WATER QUALITY MEMORANDUM

Utah Coal Regulatory Program

RE: First Quarter of 2012 Water Monitoring, Genwal Resources, Inc., Crandall Canyon Mine, C015-0032 Task ID #4019

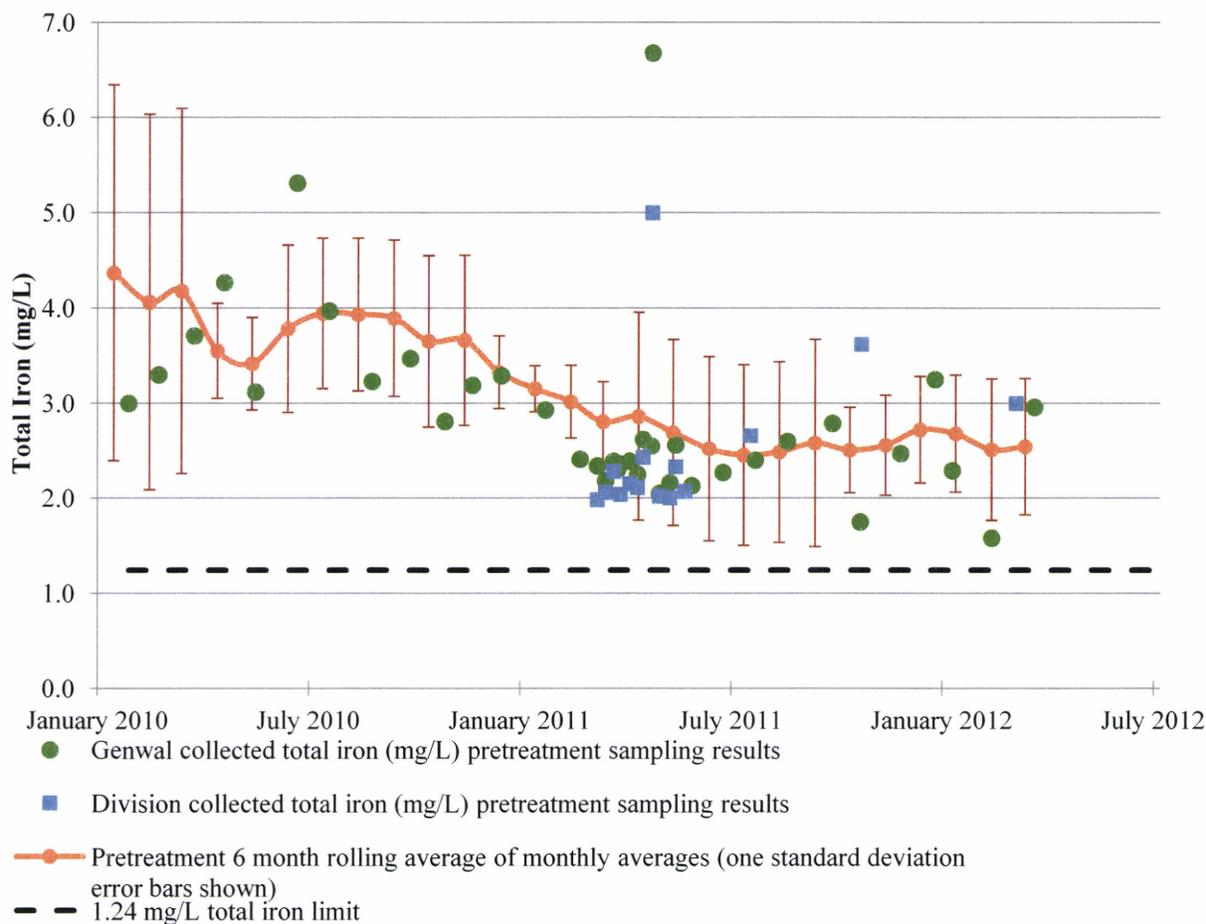
The total iron concentrations in the pre-treatment mine water remains well above the 1.24 mg/L UPDES limit. Based on three sampling events the resulting concentrations for total iron were 2.29, 1.58 and 2.21, and 2.96 mg/L for January, February (two samples), and March, respectively. In addition, the Division collected one sample in March 2012 for total iron resulting in a concentration of 3.0 mg/L. The data show that total iron concentration still remains variable but since January 2010 to March 2011 a downward trend occurred. However since March 2011 the concentration of total iron has begun to level off around 2.5 mg/L. It remains undetermined whether the concentration of total iron will decrease below the total iron maximum daily effluent limitation of 1.24 mg/L is yet to be demonstrated. In addition, bicarbonate in February 2012 and total alkalinity, and field conductivity in March 2012 were found to be more than two standard deviations from the mean. Residual polymer testing was conducted on a sample collected March 21, 2012 by SGS laboratory and determined a level of 0.16 mg/L of residual flocculent.

Below is a graph of the pretreatment total iron concentration since January 2010. The graph shows the measured total iron concentration and rolling 6 month average total iron concentration (including one standard deviation error bars) compared to the curves generated in the November 2011 Investigation of Iron Concentration in the Genwal Resources, Inc. Crandall Canyon Mine Discharge Water by Petersen Hydrologic, LLC report.

Continued data collection and monitoring of the mine-water discharge will be necessary to evaluate the effectiveness of the mine-water treatment system. Monitoring of the pre-treatment mine-water will help determine the overall chemistry of the raw mine-water and help determine if the total iron concentrations are showing any change in concentration. To this end it is critical to maintain on time submittal of the pretreatment and Outfall 002 sampling results to DOGM, as required by Appendix 7-65.
